POLICY REPORT  
DEVELOPMENT AND BUILDING

TO: Vancouver City Council  
FROM: Director of Planning  
SUBJECT: CD-1 Rezoning - 1304 Hornby Street

# 1304 HORNBY STREET FORM OF DEVELOPMENT

LEVEL 1 PLAN/SITE PLAN

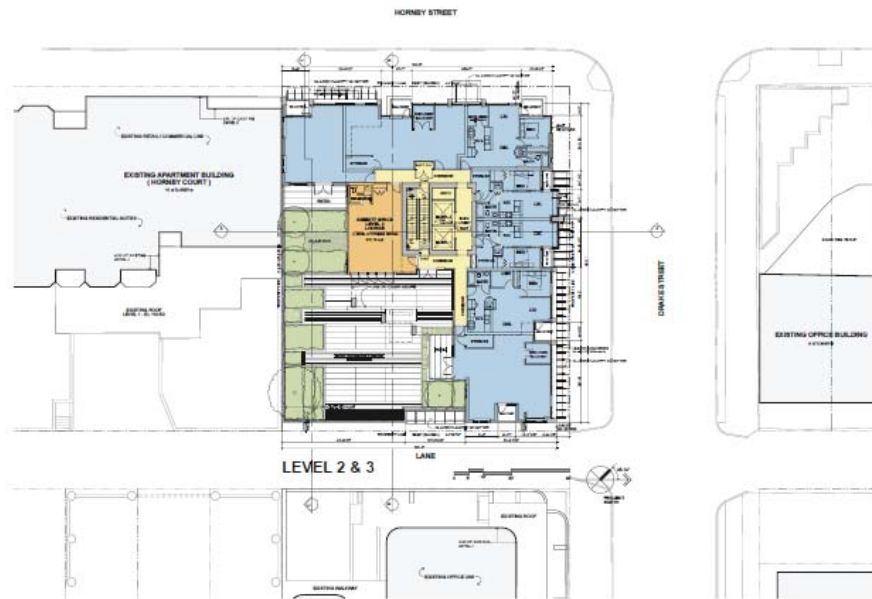
- 4. design development to extend the commercial uses fronting Drake Street to the corner;

13. provision of a detailed turning swath for access to the parkade ramp from the lane to ensure vehicles do not conflict with the card reader location or relocation of the car reader to allow for improved access;

Note to Applicant: the reader and vehicle must be on a maximum 10% grade.

14. provision of a direct connection from the commercial loading space to all retail units;
15. provision of an improved connection/route from the residential loading space to the residential lobby;
16. provision of a parking ramp slope not to exceed 10% for the first 6.1 m (20 ft.) from the property line;

Note to Applicant: the northerly side of the ramp (el. 91.92') calculates at 11.2%. Also see #13 above.

Note to Applicant: the nine riser stairs leading from the elevator lobby to the parkade exit corridor to the lane should have a wheel ramp.

ELEVATIONS

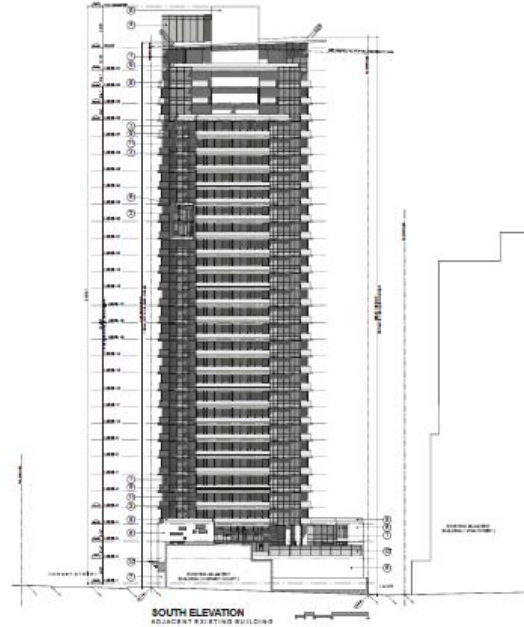
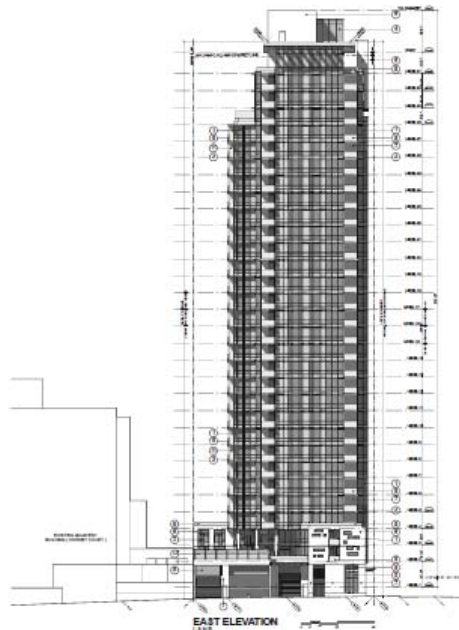
- c) Spatial separation requirements on the South elevation does not comply with unprotected openings.
- d) Building construction is required to be noncombustible.
